March 24, 2026

Re: Santa Maria Community Services
Project No. 25109
Addendum No. 5

## E201

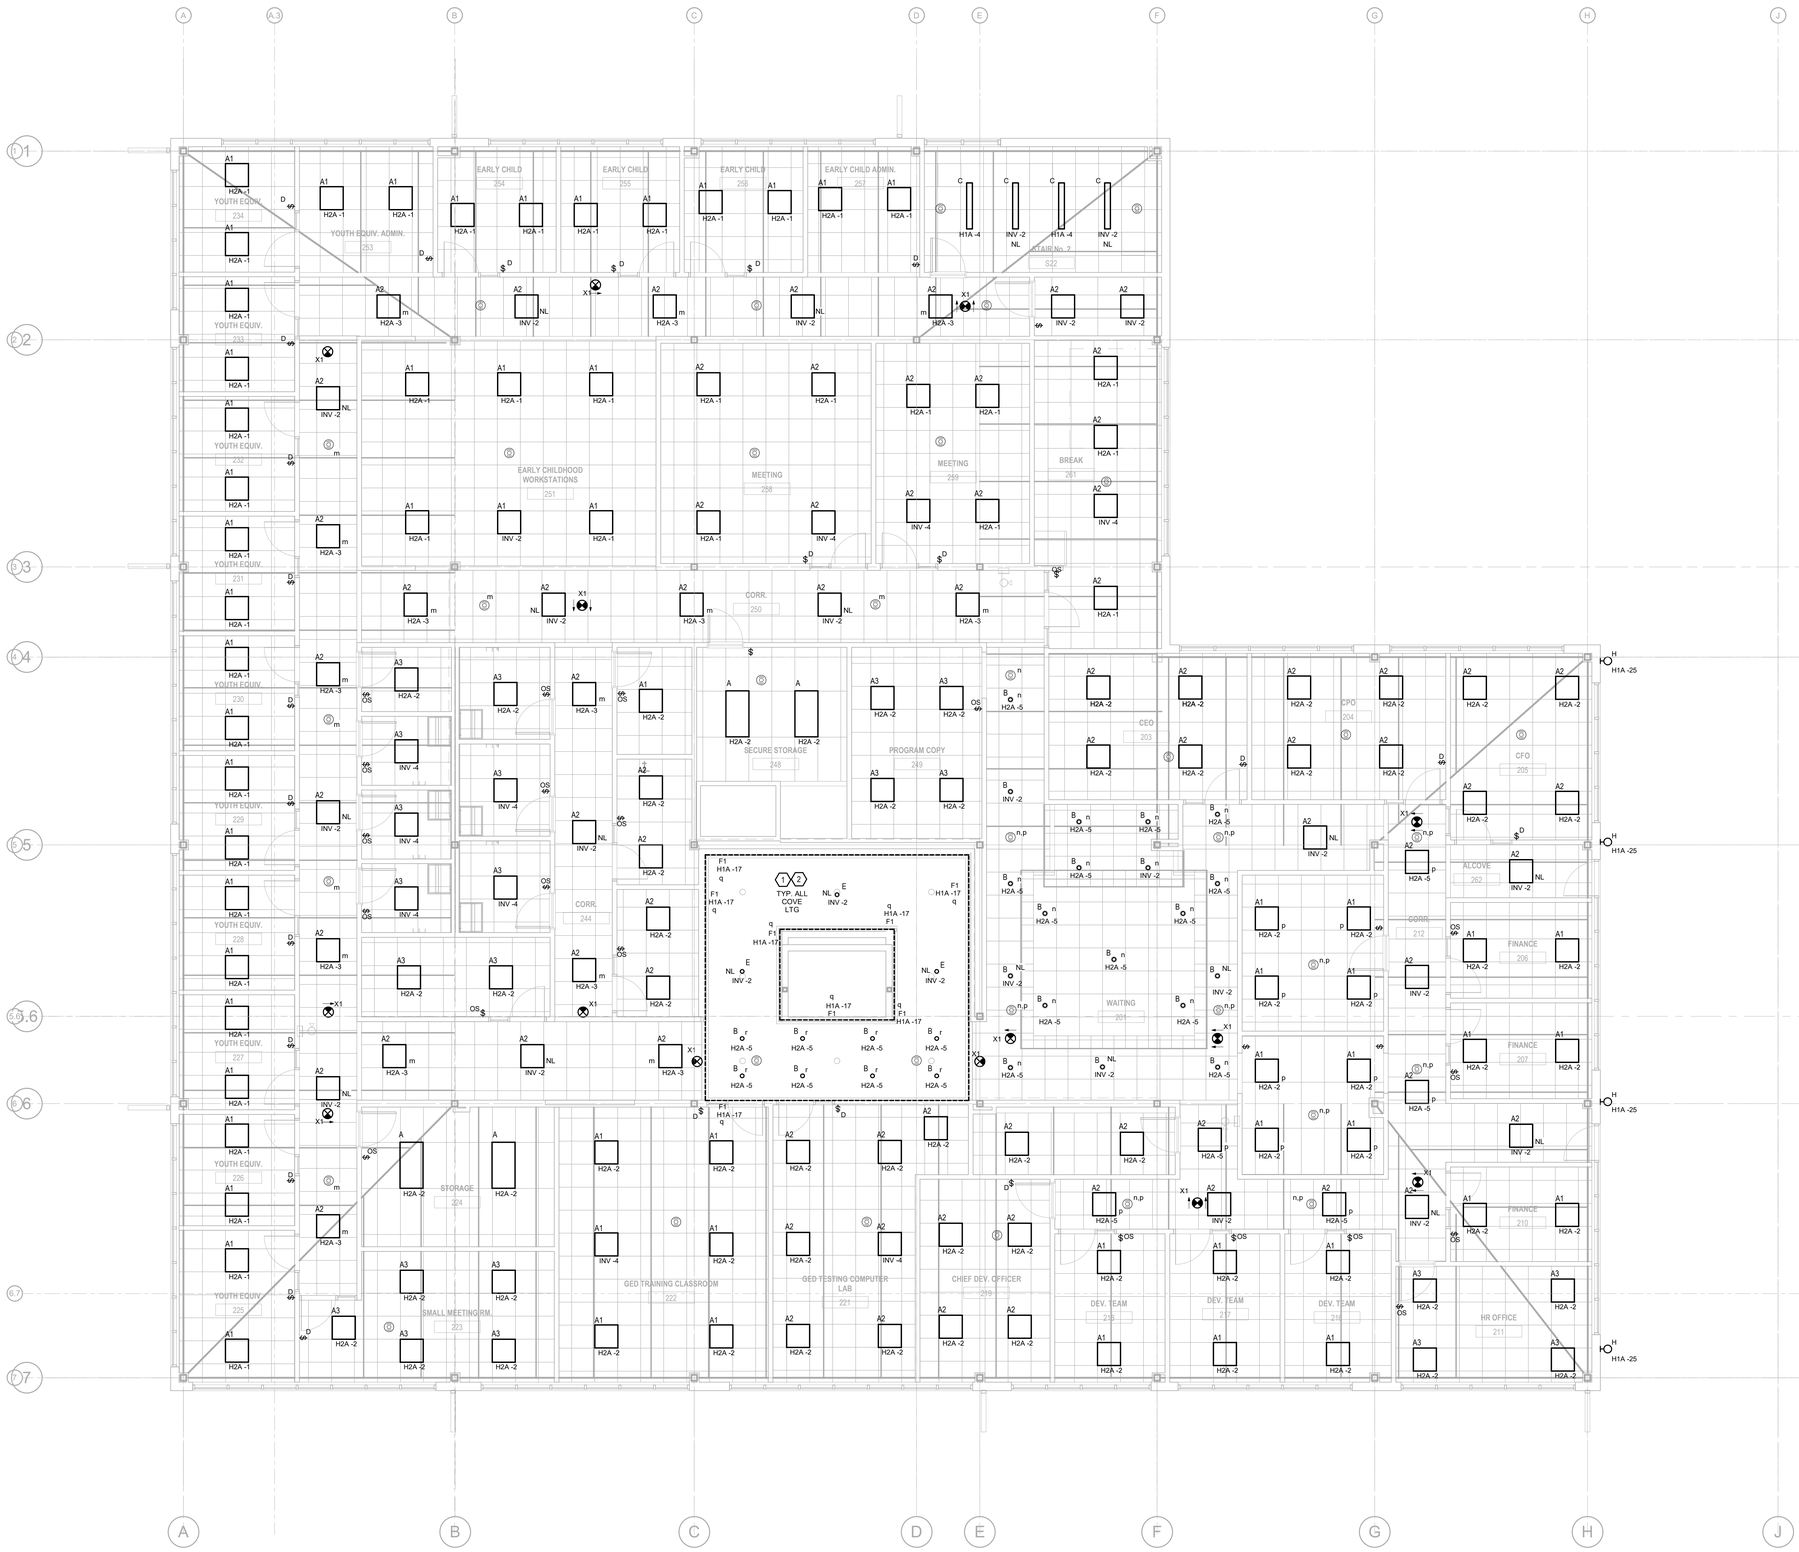
E201 Relocated various light fixtures to accommodate floor plan changes.

Updated light fixture layout in Donation Pantry and adjacent floor plan changes.
